**The Lofts at Del Ray Village
2707-2711 Mt Vernon Avenue**

Docket Item #11
DEVELOPMENT SPECIAL USE PERMIT #2007-0004
THE LOFTS AT DEL RAY VILLAGE

Planning Commission Meeting
May 1, 2007

ISSUE: Consideration of a request for approval of an amendment to a development special use permit with site plan, subdivision and modifications to increase the building height, increase the size of the building, revise the uses and a parking reduction.

Fig 4: Proposed Mezzanine Footprints and Third Floor Roofs

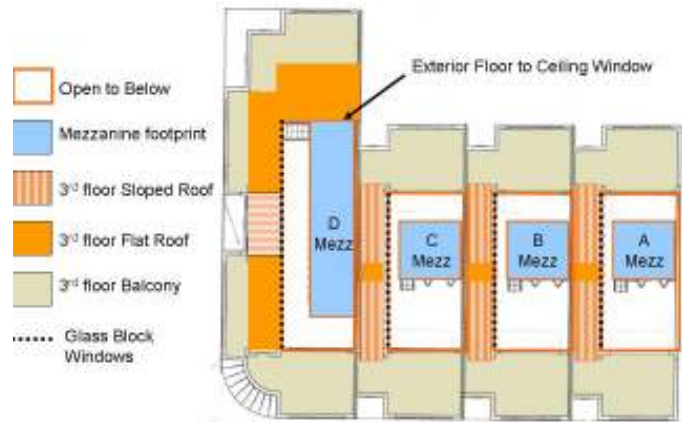
Unlike most areas of the City, Mount Vernon Avenue is regulated by both the maximum height (40-45 ft.) and number of levels (three). In this case, the applicant is proposing a fourth level mezzanine that occupies approximately 40% of the upper portion of the building. The number of floors and height were established on Mount Vernon Avenue to allow flexibility to the mix of uses permitted such as retail, office and residential. While “loft-type” units are encouraged on Mount Vernon Avenue, the 650 sq.ft. of mezzanine space proposed within the fourth level attempts to take advantage of the form based code and staff is concerned about precedent being set for other projects as a way to essentially build a 4-level building within the maximum 45-foot height limit. Therefore, staff is recommending that the proposed mezzanine not constitute more than 20% of the upper portion of the building. In addition, staff is recommending to slightly reduce the height of the building.

While staff generally supports the proposal and finds that it is mostly in conformance with the intent of the Plan, with the reduction in the area of the mezzanine and height, staff is recommending approval.
